DATE October 21, 2020

TO John Rygh
Save the South Fork
Pete Dronkers
Earthworks

FROM Betsy Semmens, RG

I have reviewed portions of the Draft Environmental Impact Statement (*Stibnite Gold Project, Draft Environmental Impact Statement*, United States Department of Agriculture, August 2020 (DEIS, 2020, referred to hereafter as “the DEIS”)) and the following groundwater modeling reports by Brown and Caldwell (BC) to evaluate potential impacts to groundwater from proposed mining activities at the Midas Gold Stibnite mine in Idaho:

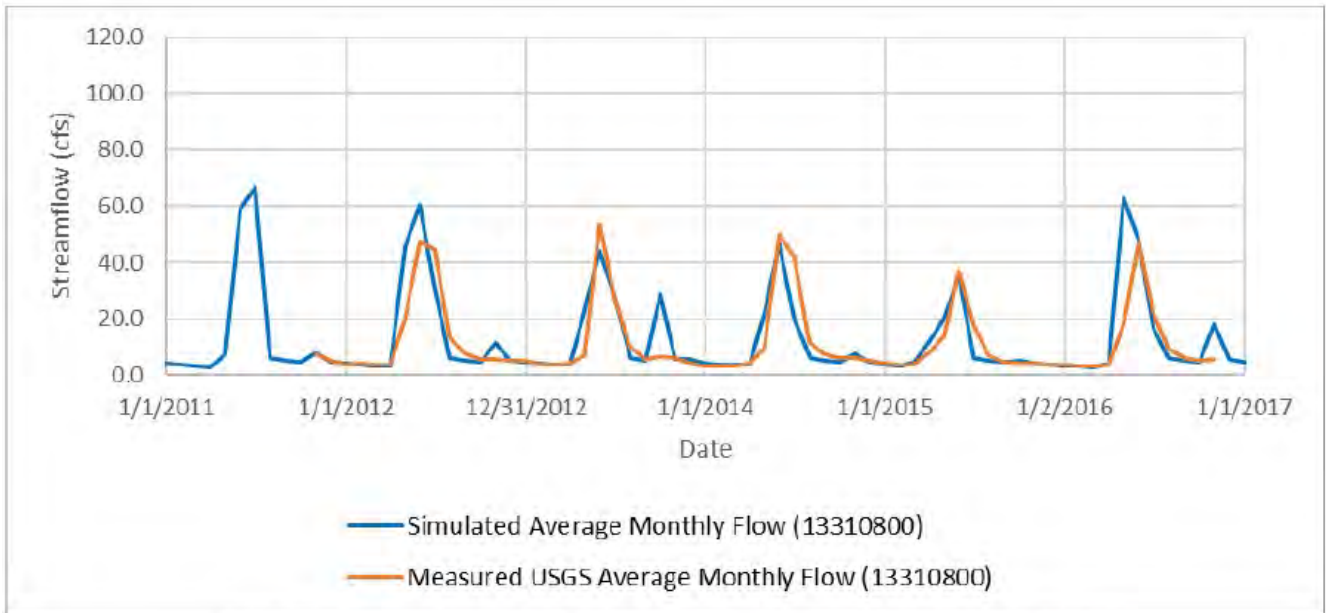
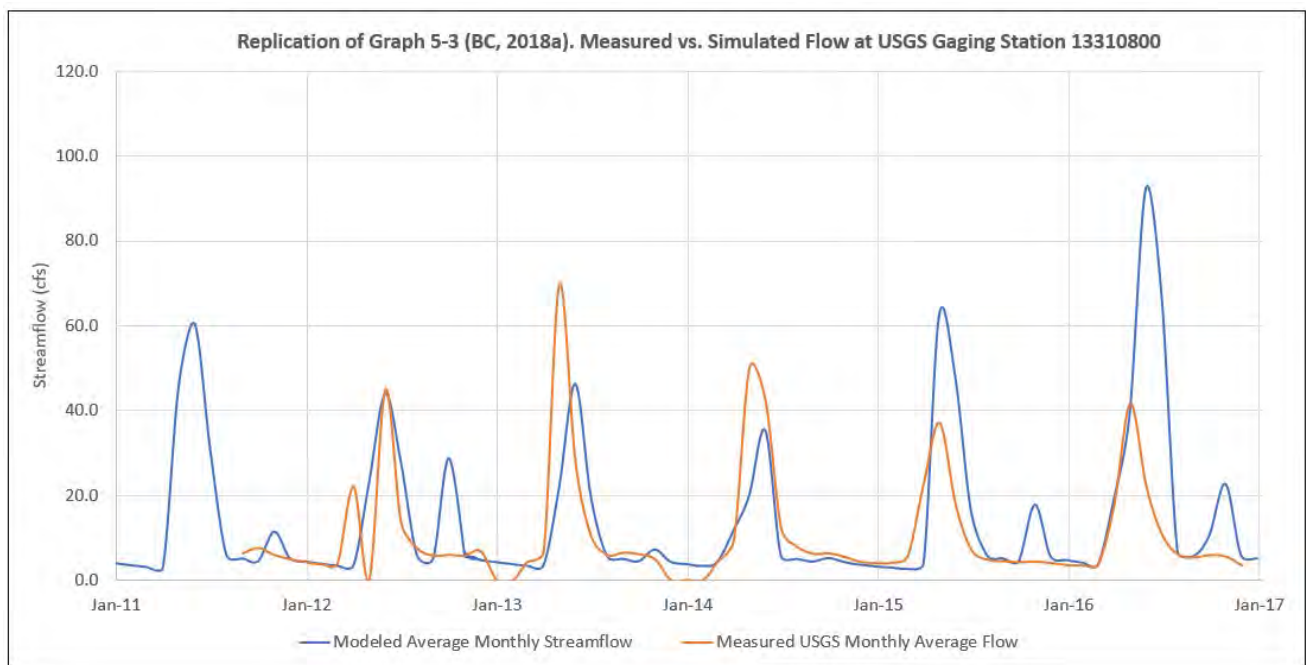
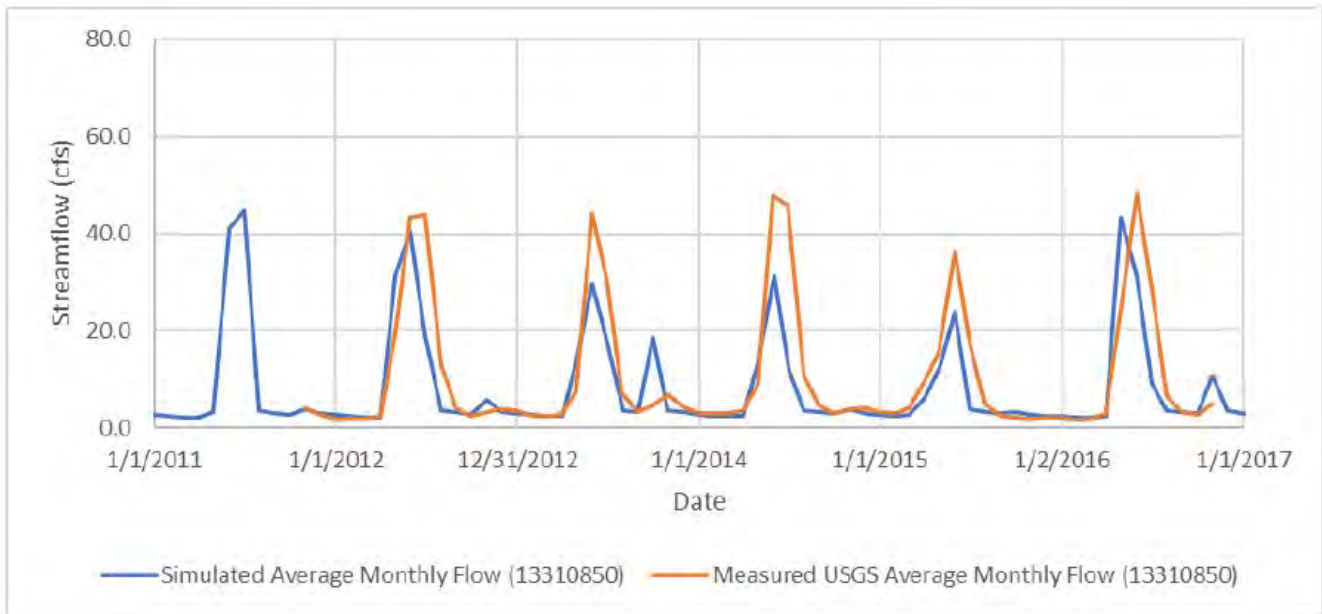
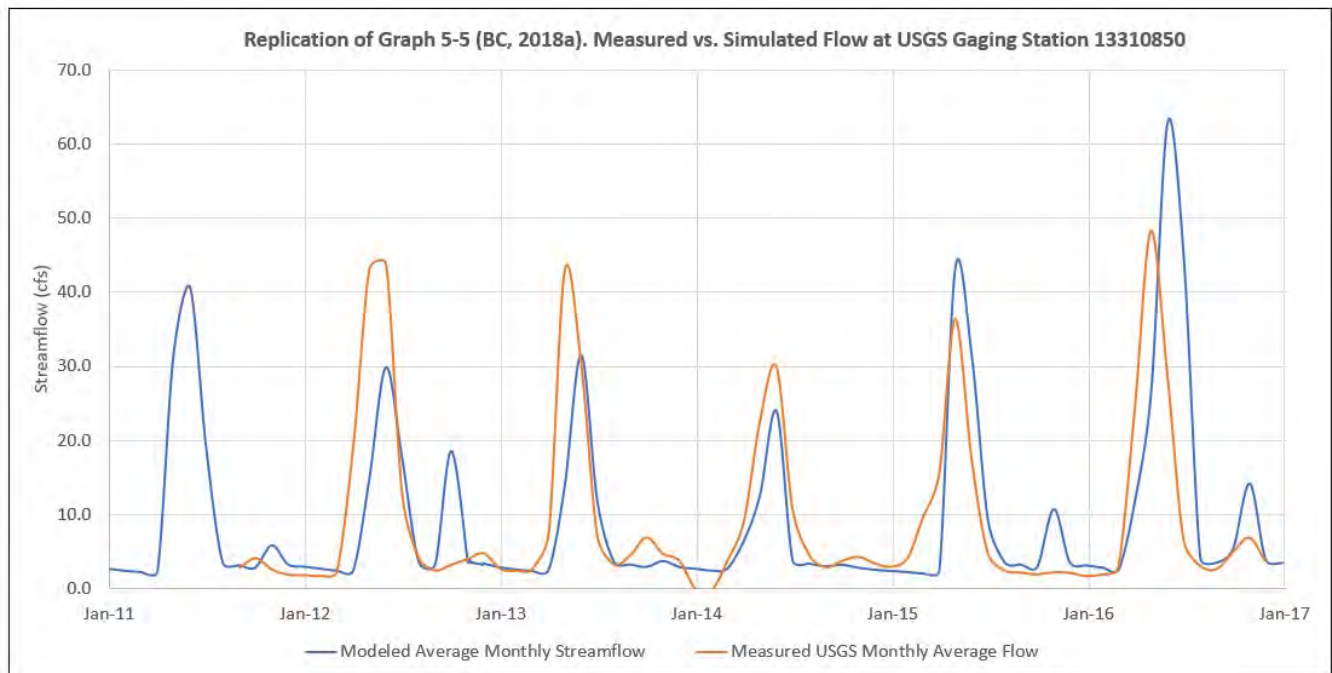
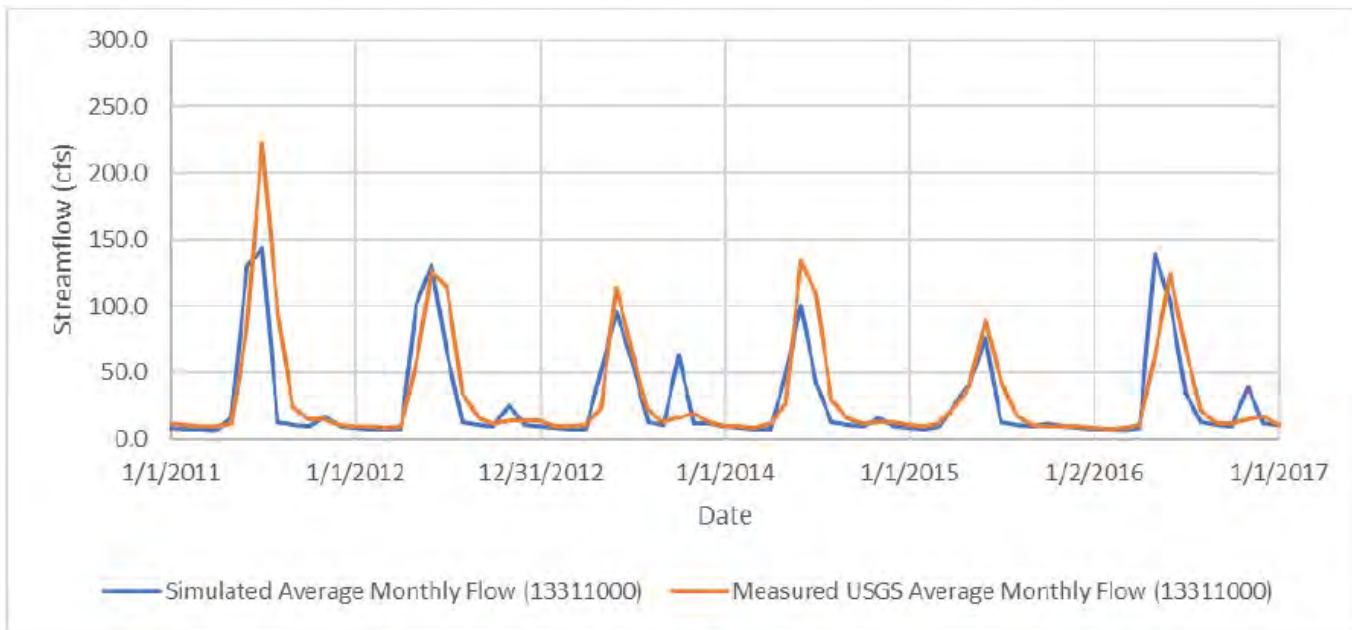
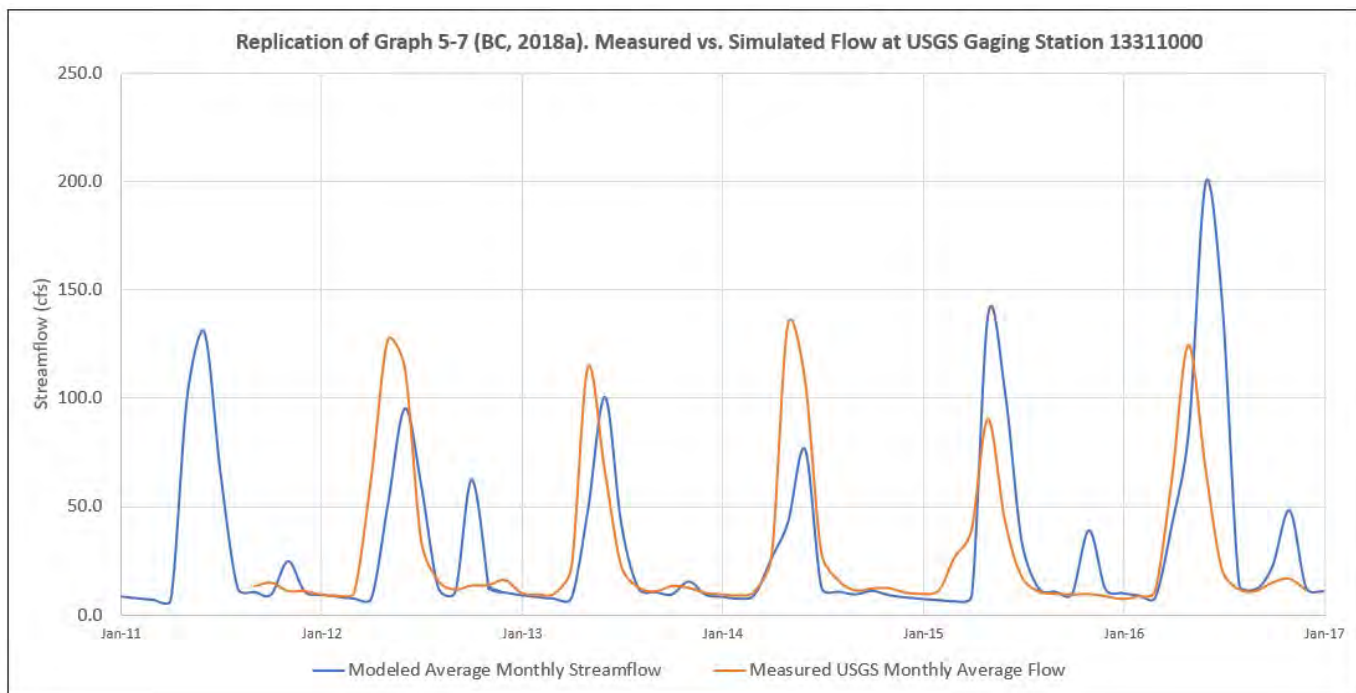
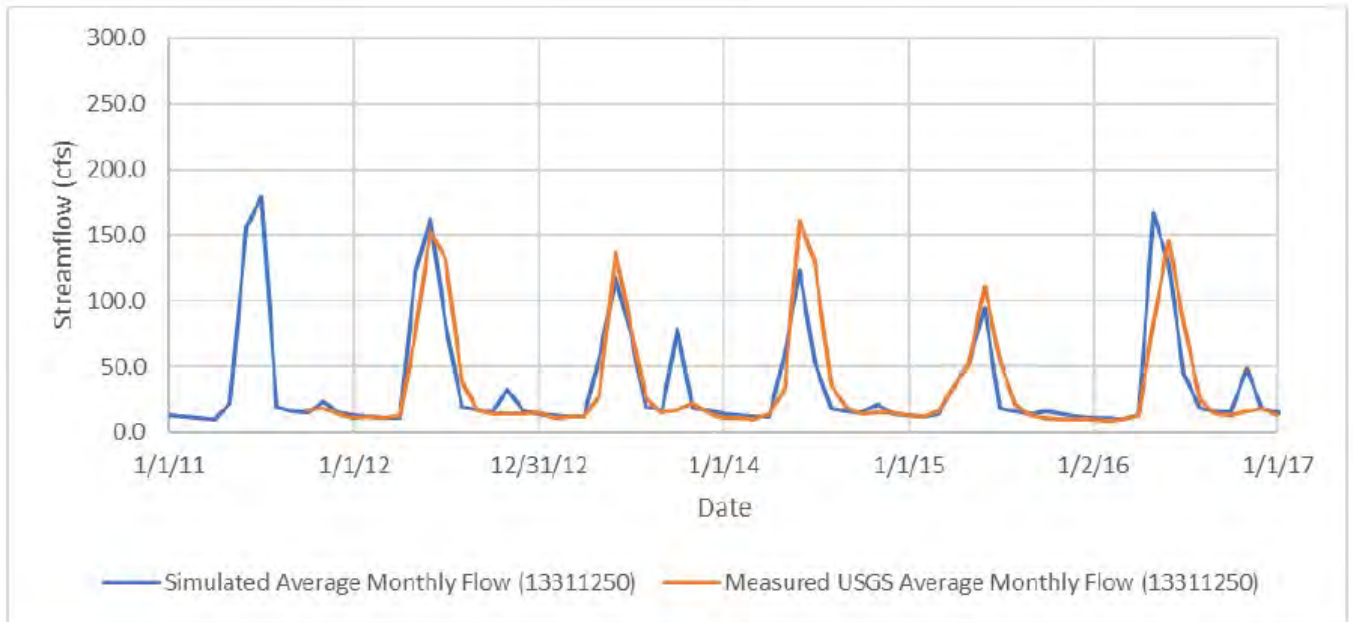
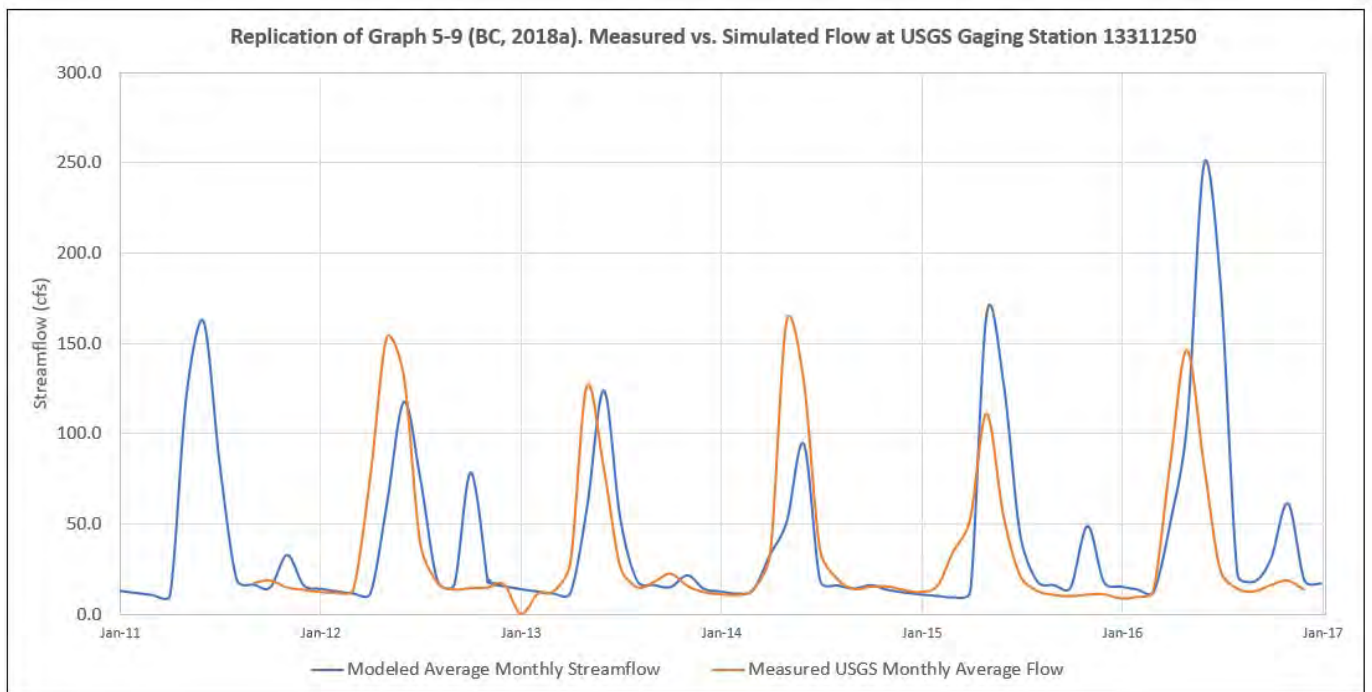
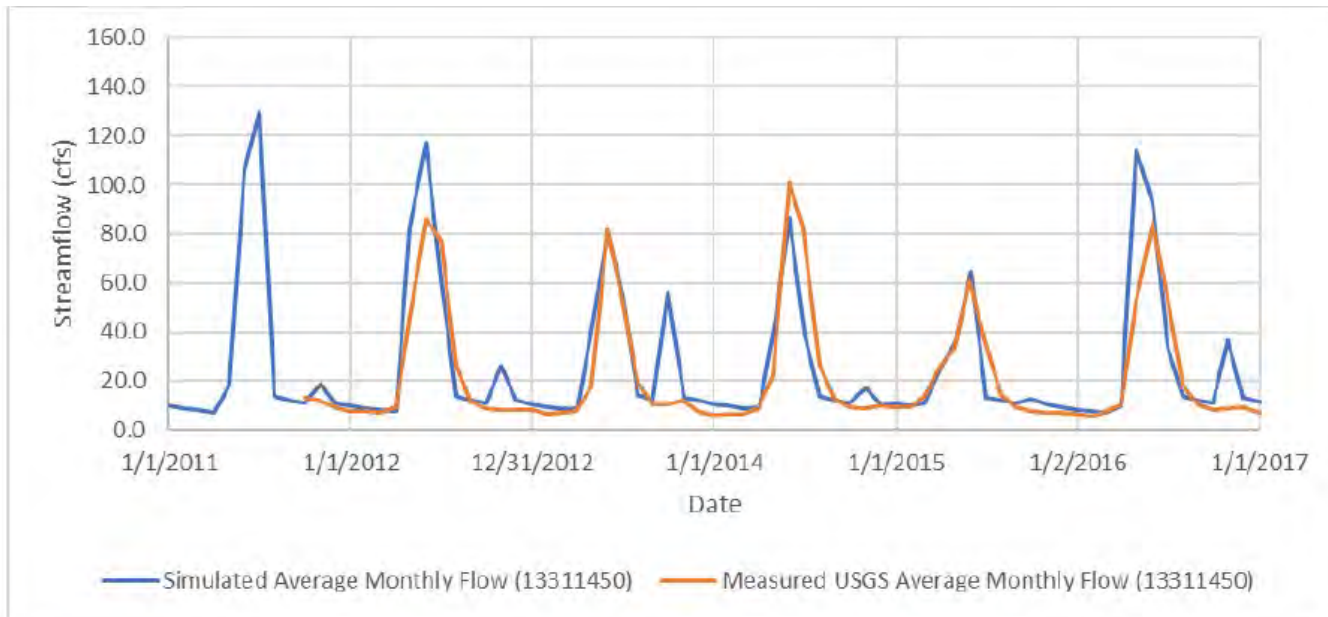
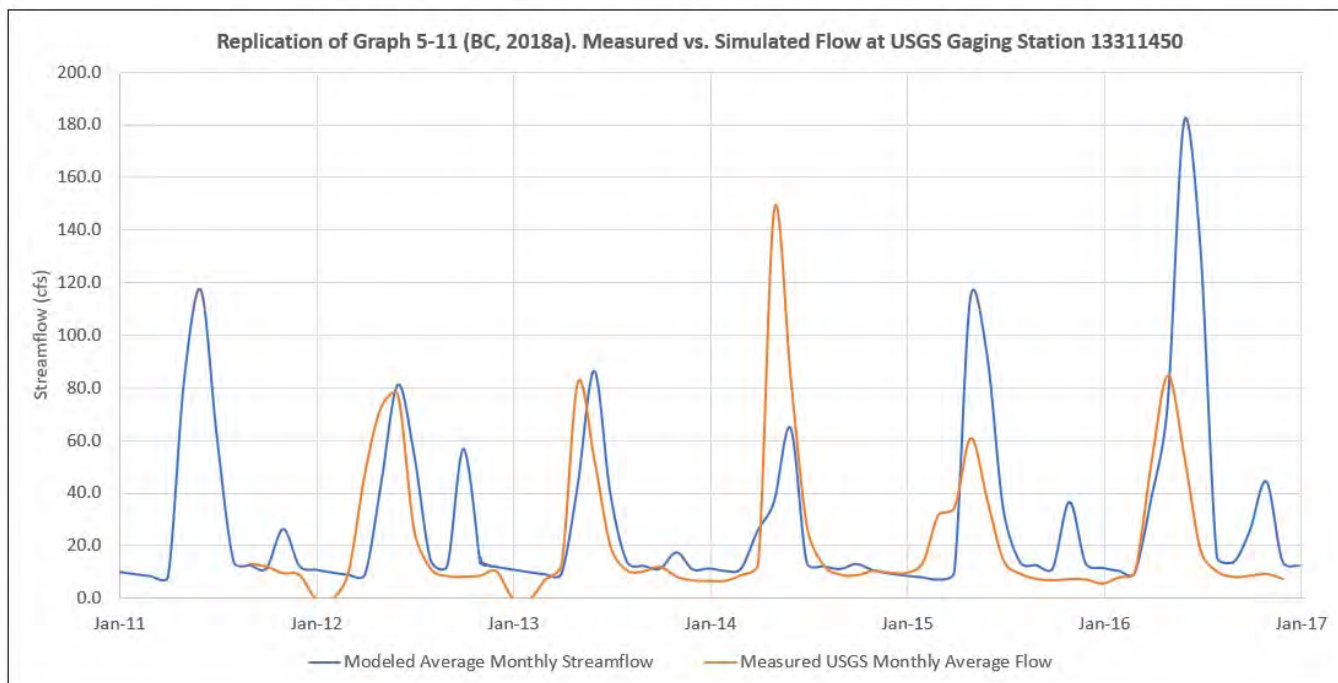
Matching the modeled streamflow to measurements of streamflow in United States Geological Survey (USGS) gaging stations was a major component of the model calibration. Graphs were provided showing a very close match between modeled streamflow and measured streamflow for the period 2011 to 2017 at five USGS gaging locations:

I downloaded the gage data for these USGS gaging stations and replicated the graphs shown in the existing conditions modeling report (BC, 2018a) to compare the model output from the provided model files (*Midas_ExistingCond.gww*). The gage data were averaged monthly to be consistent with the data shown in Section 5 of the existing conditions modeling report (BC, 2018a). In general, the graphed output from the provided MODFLOW-NWT files for existing conditions does not match the output shown on graphs in the existing conditions modeling report (BC, 2018a), and in some places, the graphed measured gage data also do

not match. The difference between the modeled and measured streamflow is greater in the graphs that I produced from the model runs from the provided MODFLOW-NWT input files than what is shown in the modeling report (BC 2018a). In other words, the calibration to the measured streamflow is not as good when assessed from the replications of the graphs using the rerun model results.

Figure 4. Simulated drawdown at mine year +12 (model time = 14 years), for the provided Proposed Action model (green), and CA Test 1 (yellow) for drawdown 5 feet and greater.

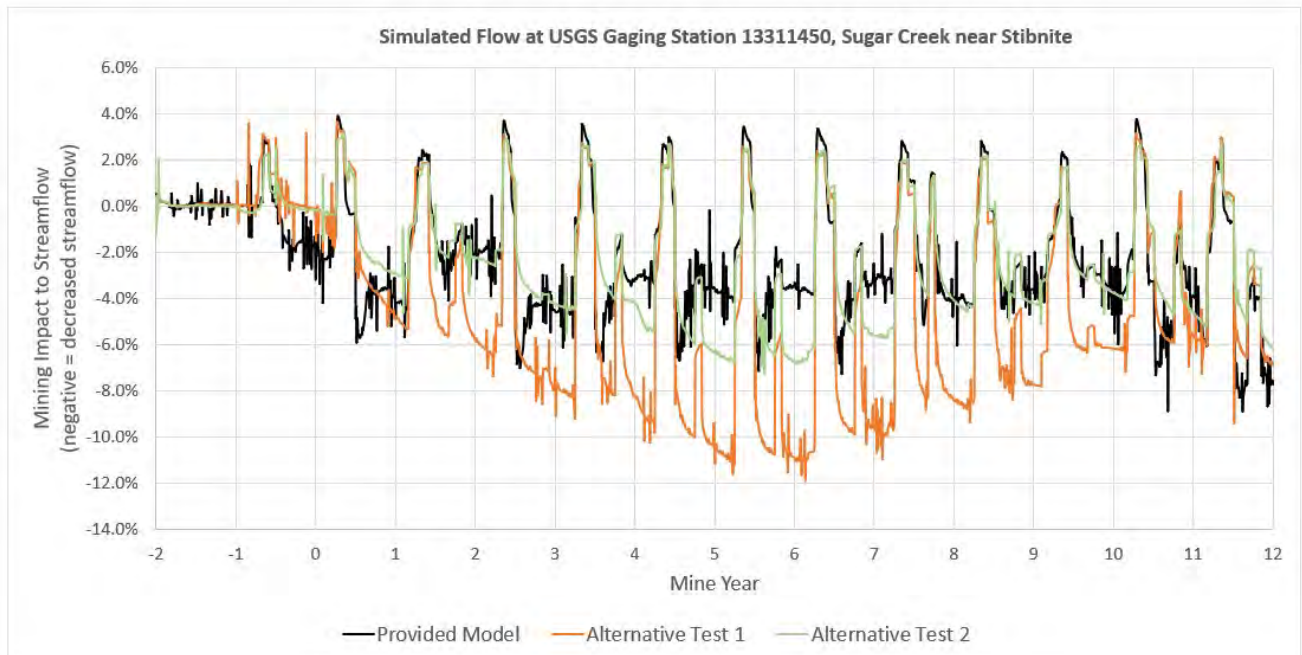
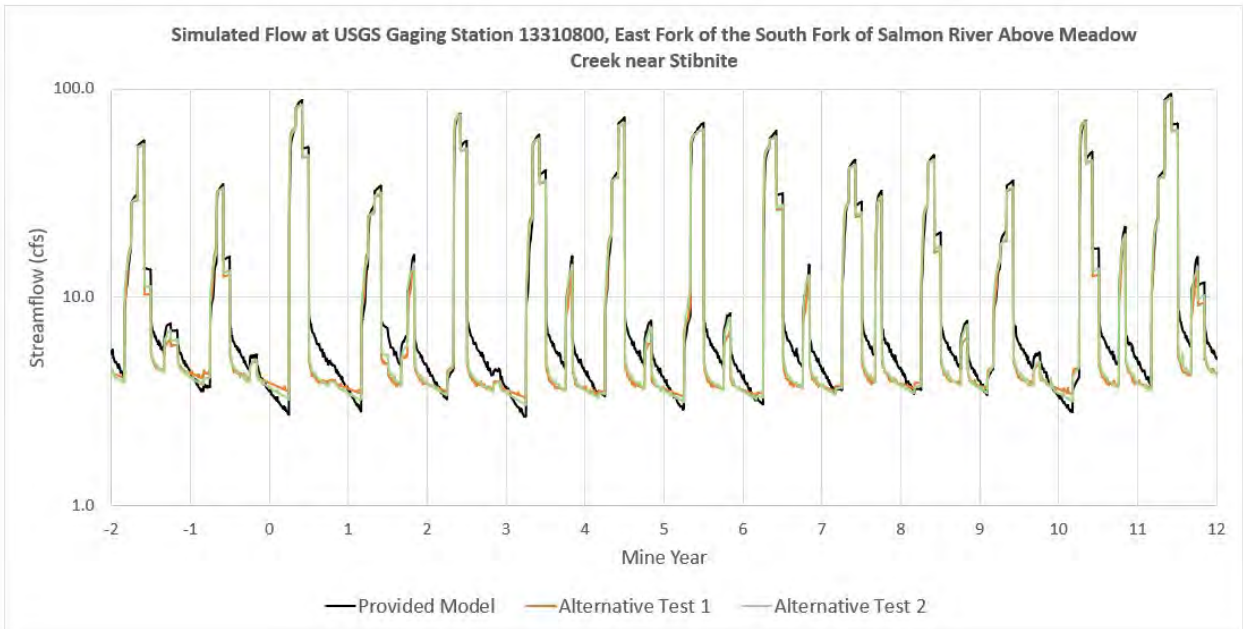
Lastly, drawdown of the groundwater surface due to mining was compared between the provided Proposed Action model and CA Tests 1 and 2. Drawdown was calculated as outlined in the Proposed Action modeling report (BC 2018b) for alluvium (model layer 1) and shallow bedrock (model layer 2) at the same time intervals (mine years 6, 7, and 12) by subtracting groundwater elevations in the mine operations models from the no action models. The simulated extent of drawdown was greater within the shallow bedrock (model layer 2) in CA Tests 1 and 2 compared to the provided Proposed Action model. Near the Yellow Pine and West End pits, simulated drawdown in the shallow bedrock extends further across Sugar Creek, and extends further south of the pits toward Hangar Flats, with differences in the simulated extent of the 5-foot drawdown contour up to approximately 500 percent in CA Test 1 (Figure 4 below). Near Hangar Flats pit, simulated drawdown extends further in all directions by approximately 130 to 330 percent. The Proposed Action modeling report (BC 2018b) suggested that drawdown in the alluvium is more important than drawdown in the shallow bedrock because of the potential interaction with surface water streams. But if the predicted extent of drawdown in the shallow bedrock is greater than expected, seeps, springs, and groundwater dependent ecosystems could potentially be impacted, as well as downgradient streamflow (DEIS Section 4.8.6).

The simulated contours of drawdown for CA Tests 1 and 2 reached the model boundary downgradient of the Yellow Pine pit. This indicates that the model boundary is too close to the pits to allow proper testing of the impacts of dewatering the pit. Exterior model boundaries should be located far enough from the features of interest, so they do not impact the predictive results. The radial nature of groundwater discharge to these open pits cannot properly be simulated if the model boundary encroaches upon the pit. This impacts not only the CA

Tests 1 and 2 discussed here, but the predictive modeling presented in the Proposed Action modeling report and Modified PRO modeling report (BC 2018b, 2019b).
